MESA SUBSTATION

MOUNT JOY TOWNSHIP, LANCASTER COUNTY, PA

Re: MESA Substation
Preliminary/Final Land Development Plan
Township Permit No. 2026-02-FLDP
LCEC Project No: 25-208

We have received a preliminary/final land development plan submission from Harbor Engineering, Inc. for the above-referenced project. The submission consisted of the following documents:

SHEET TITLE
COVER SHEET
AS NOTED

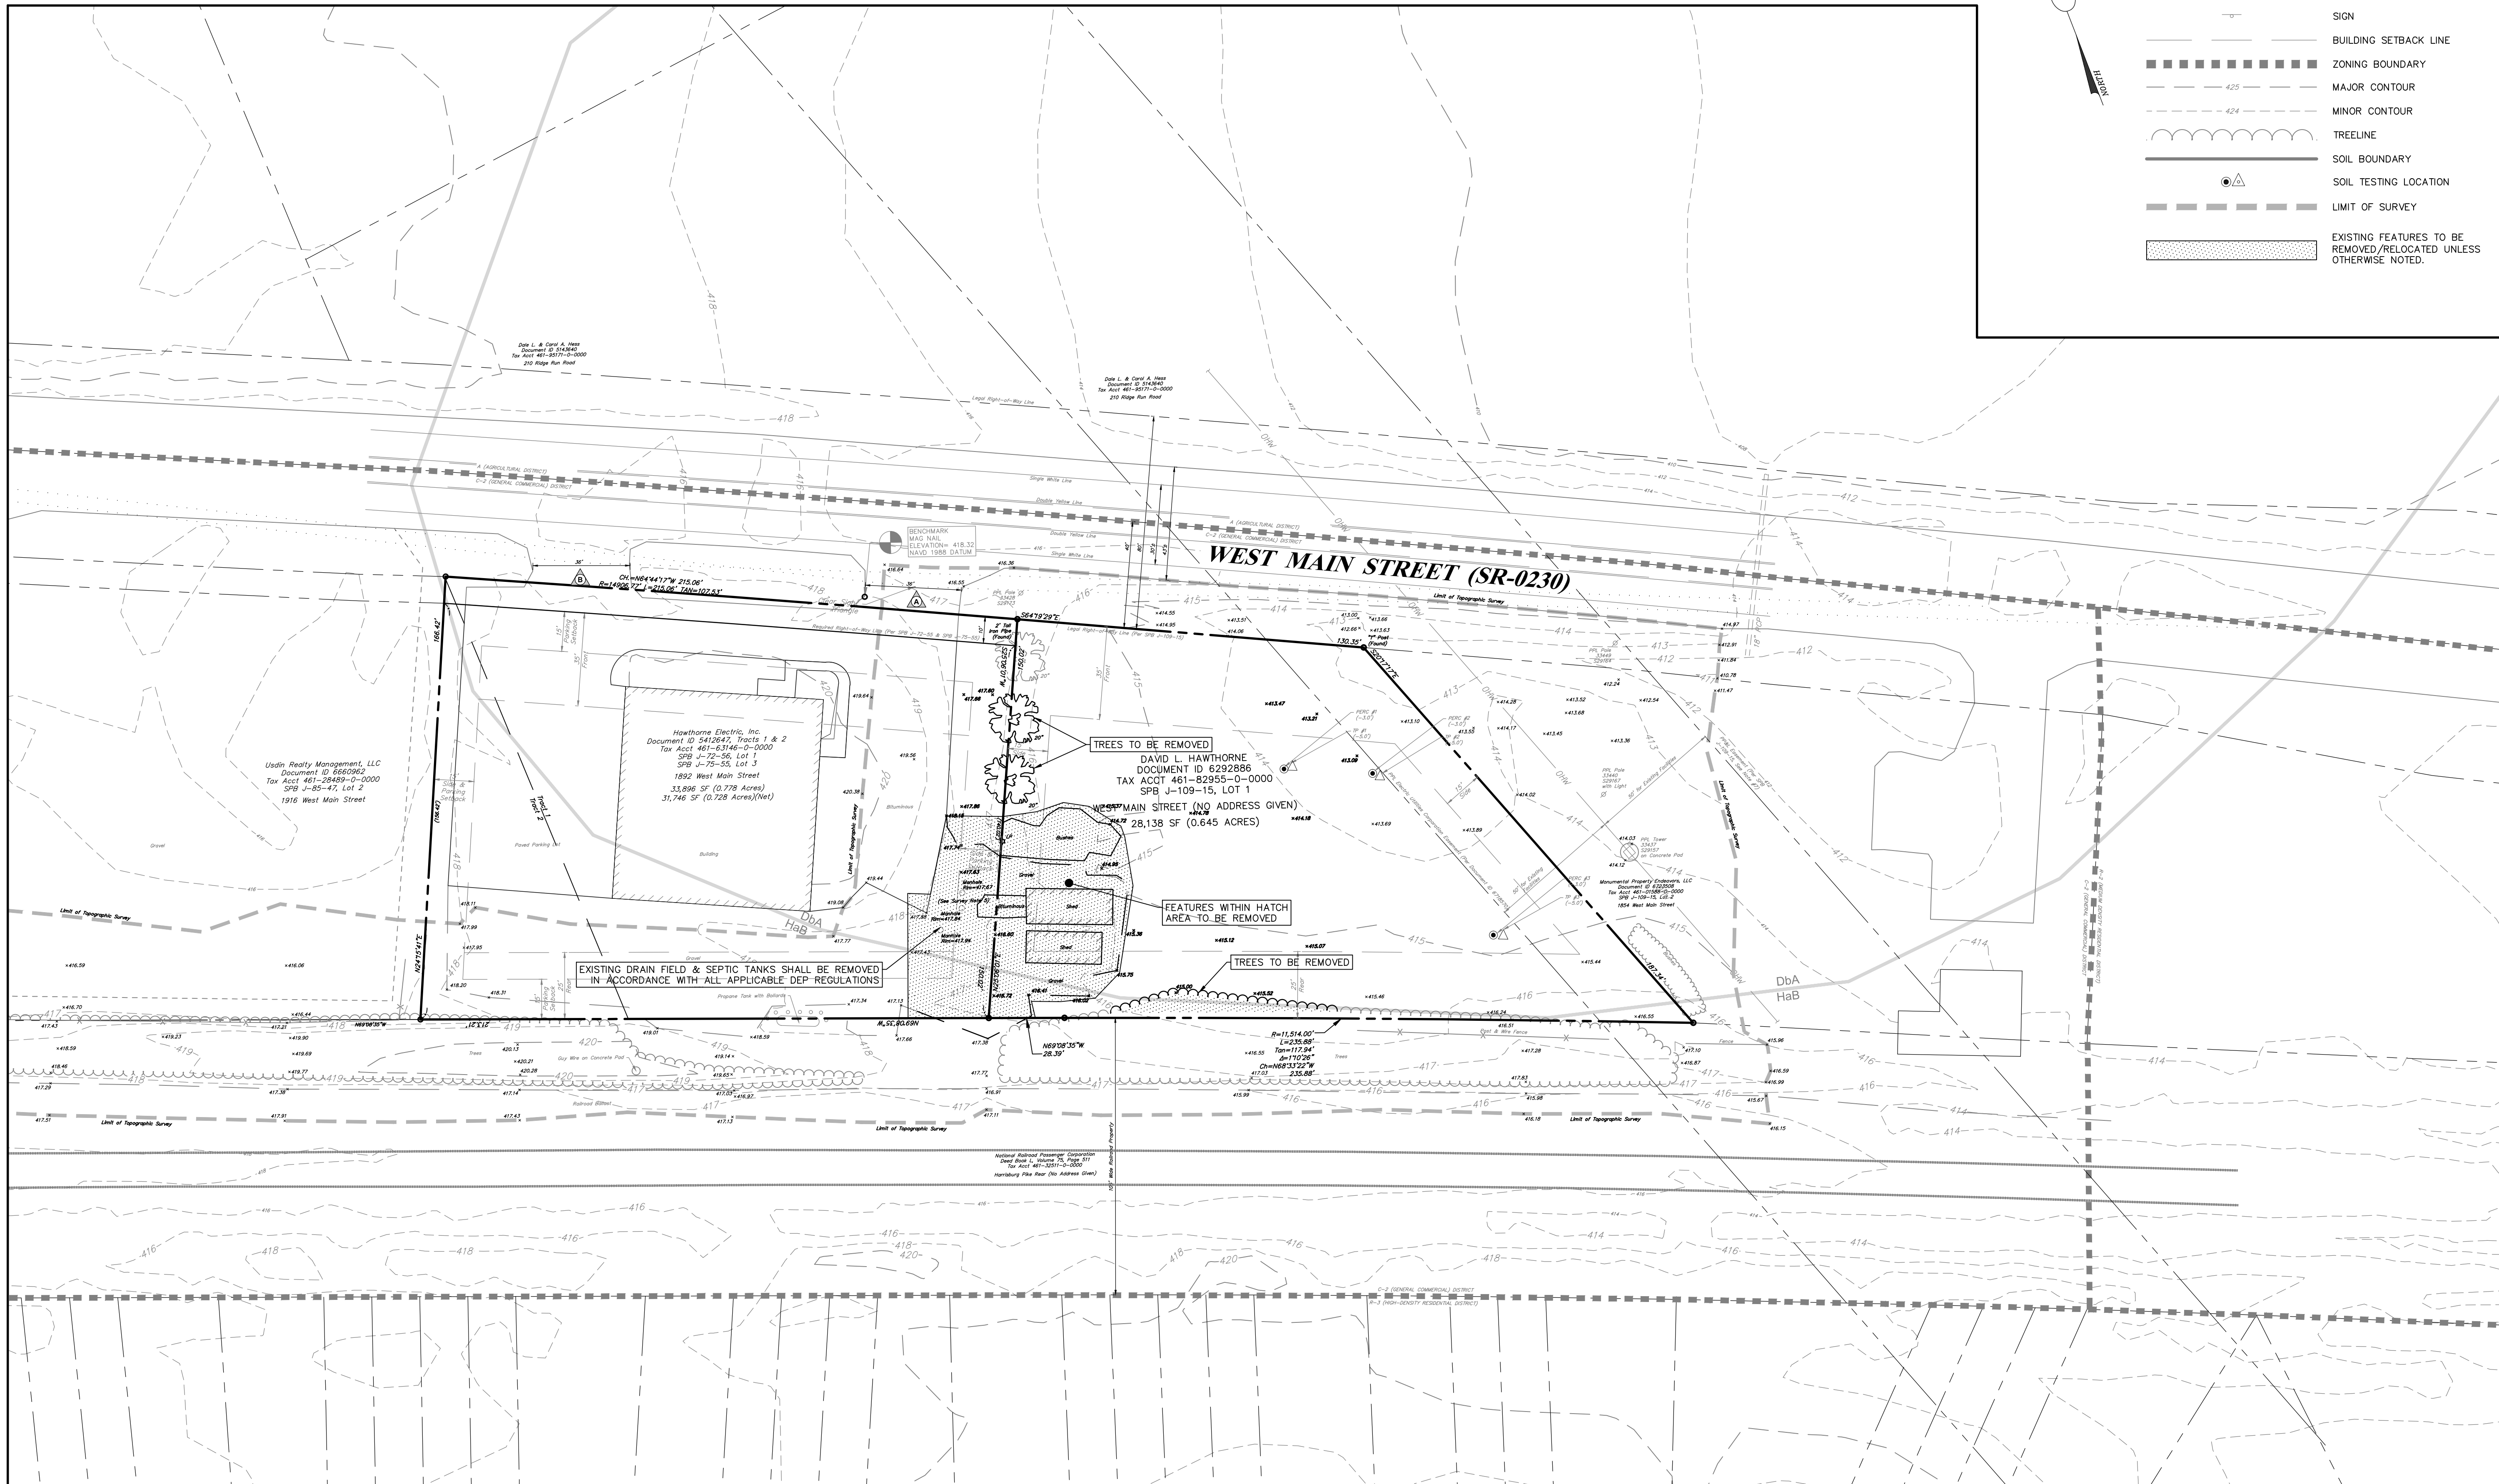
14. The proposed building and lot coverages shown for the West Main Street lot in the Site Data table on the Cover Sheet shall be updated (113-31.H(1)). For clarity, I recommend that the future impervious area be noted in the Site Data table on the Cover Sheet.

GRADING PLAN

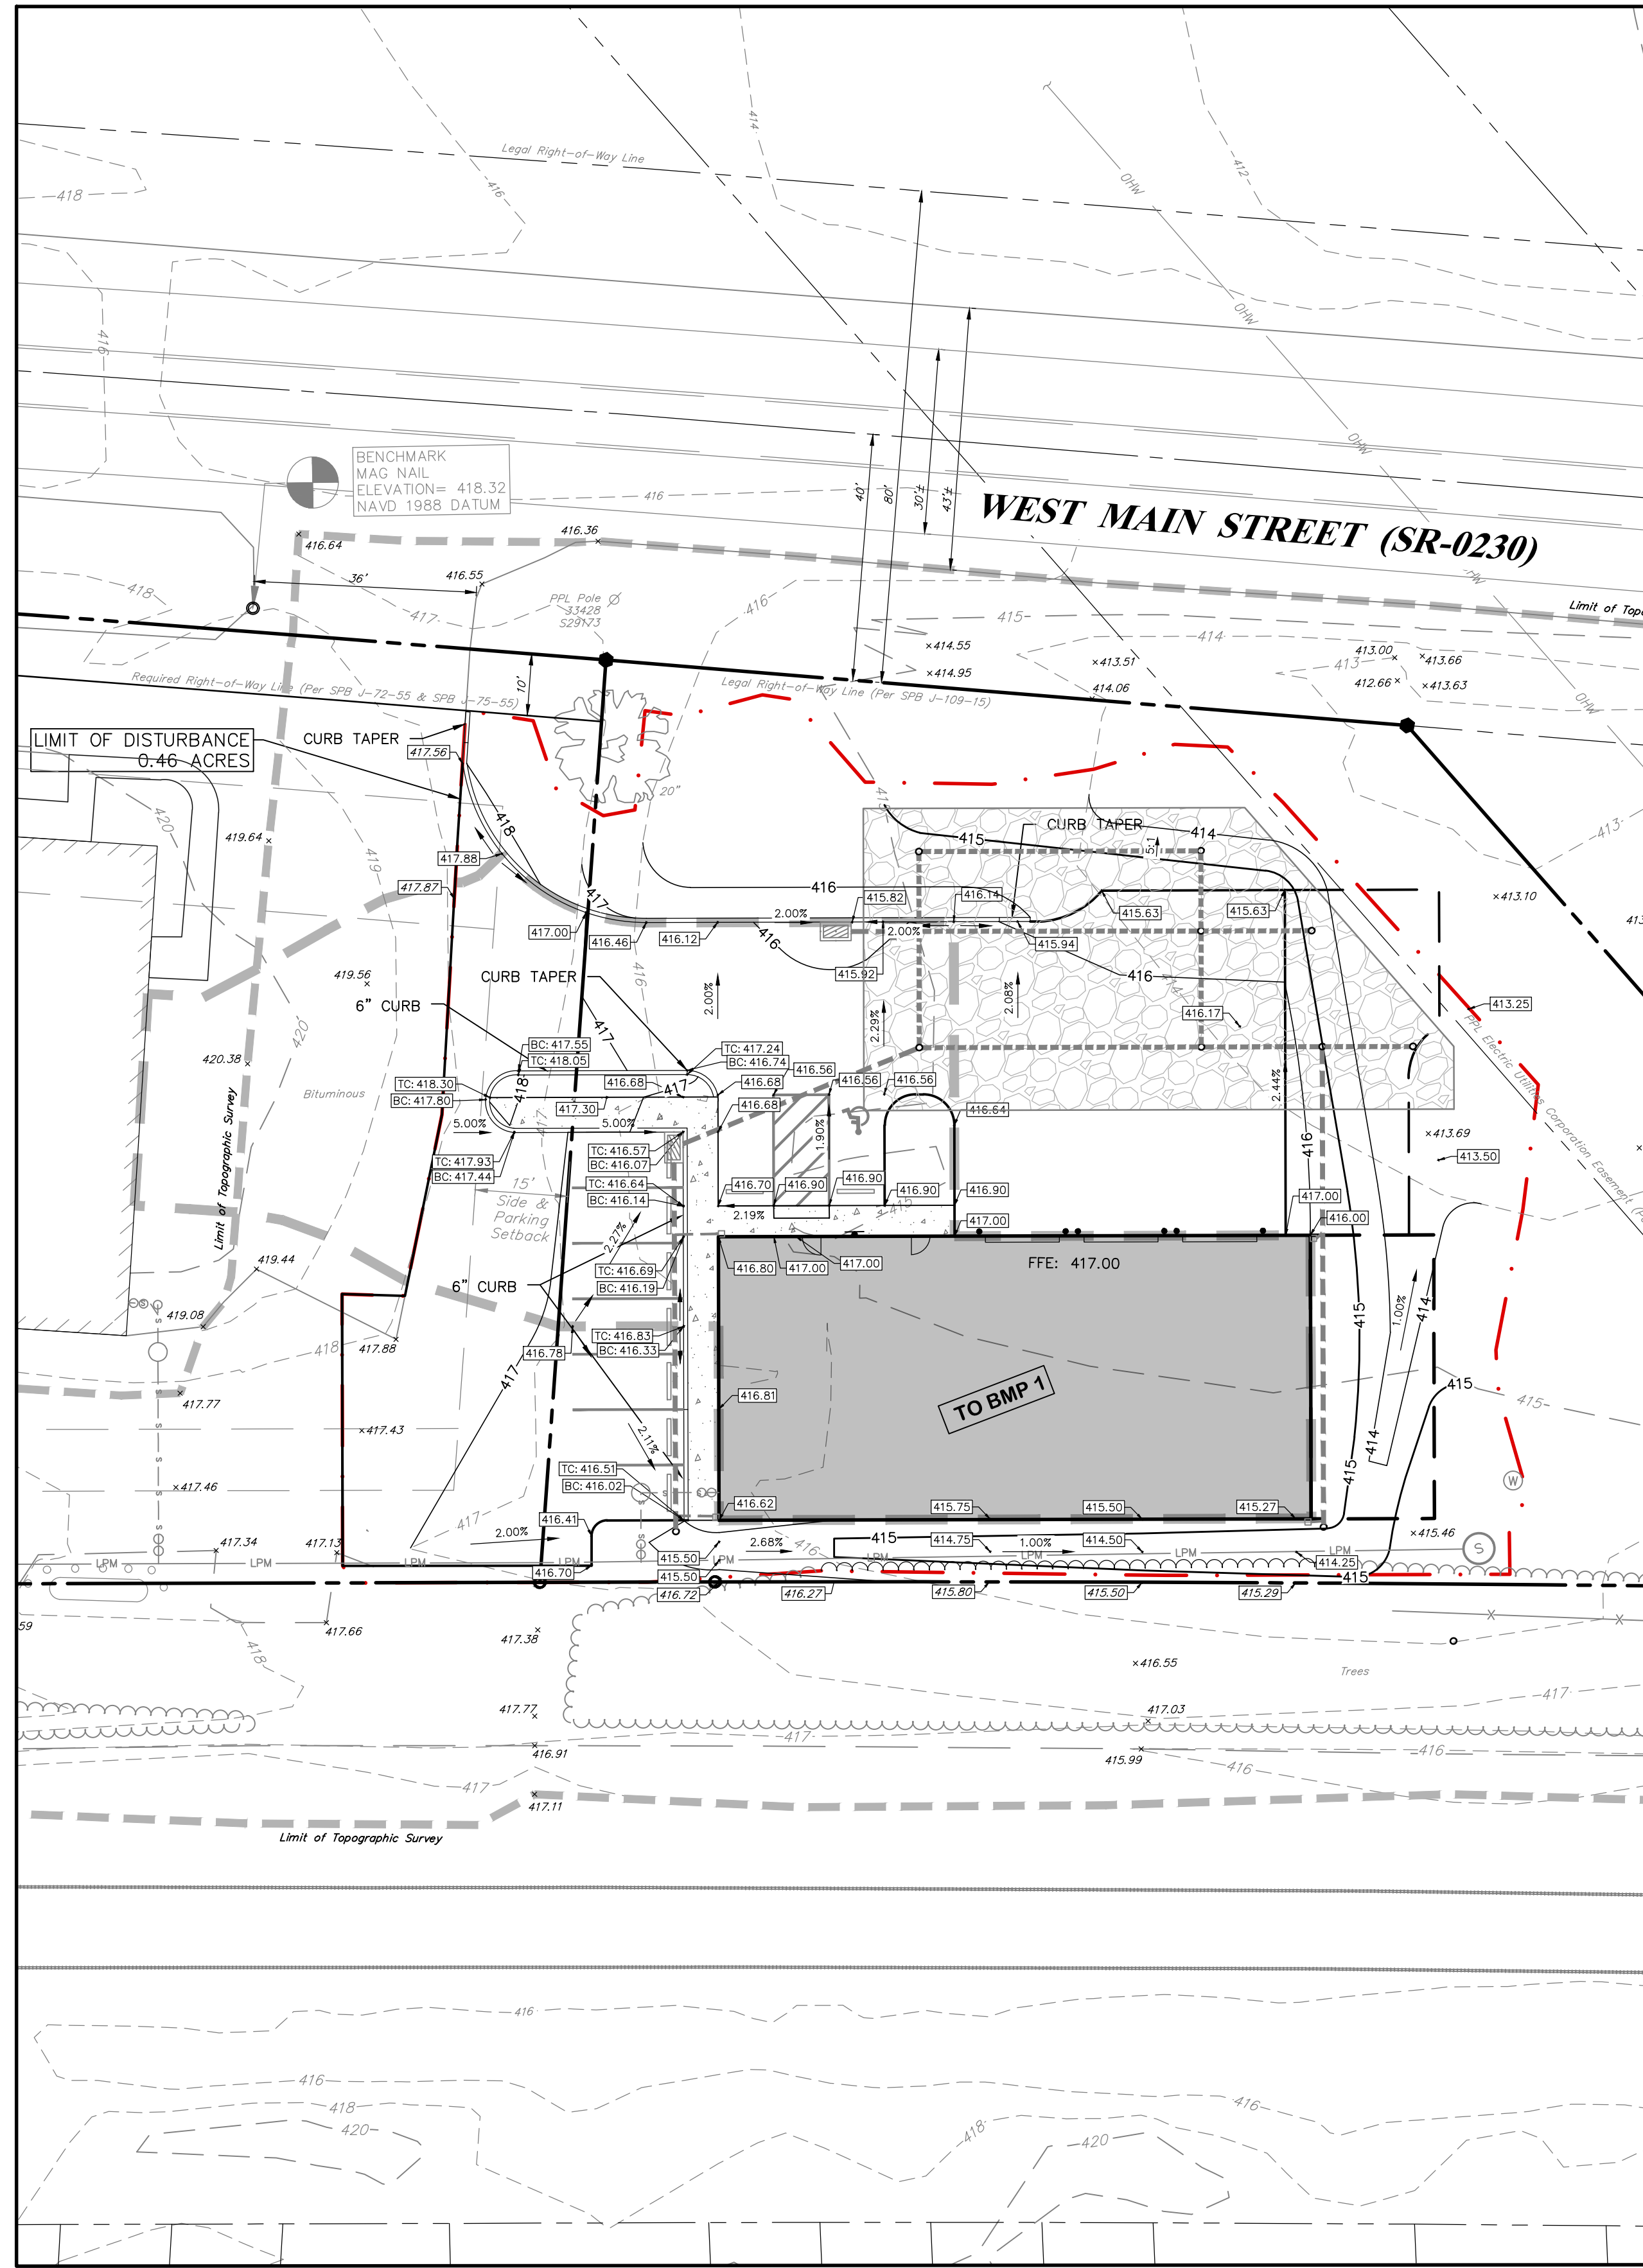
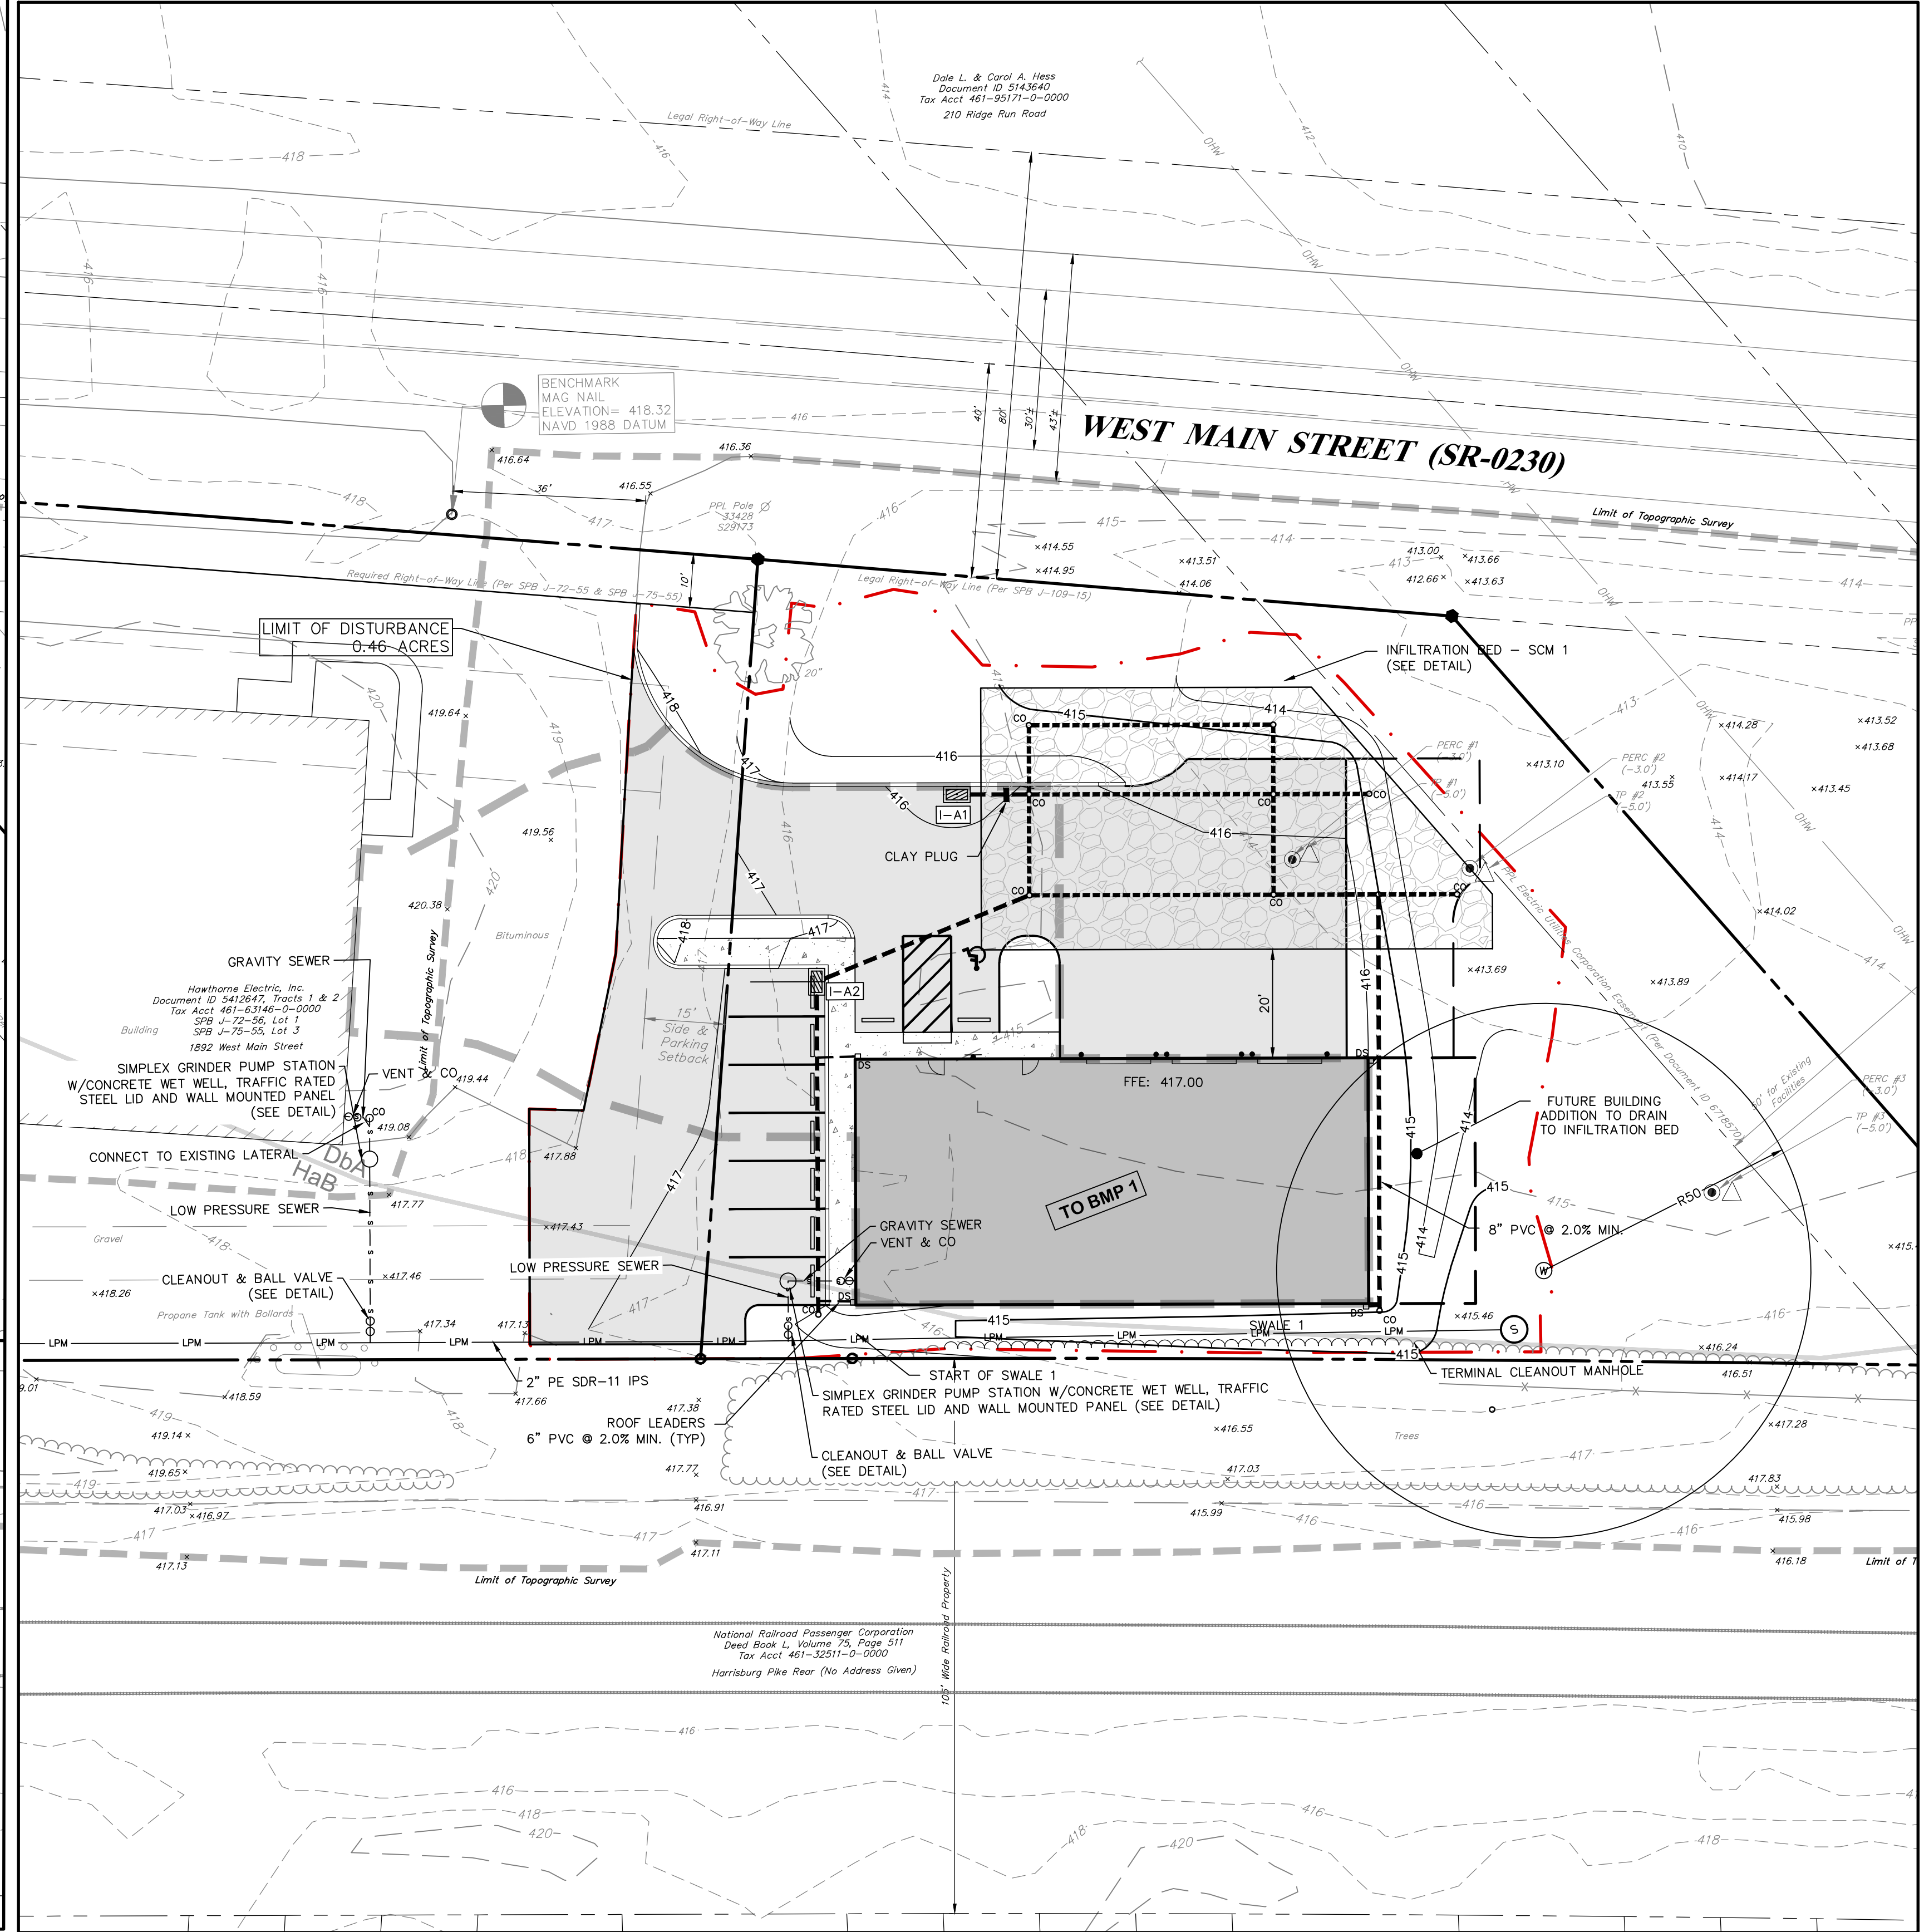
15. The limit of disturbance shown on Sheet 6 of the plans shall be updated (113-31.N(3)).
16. A minimum thirty-foot-wide access easement shall be provided for all stormwater facilities with tributary areas equal or greater than 1,000 square feet and not located within a public right-of-way (113-31.Q). Access easements shall provided for ingress and egress to a public right-of-way.
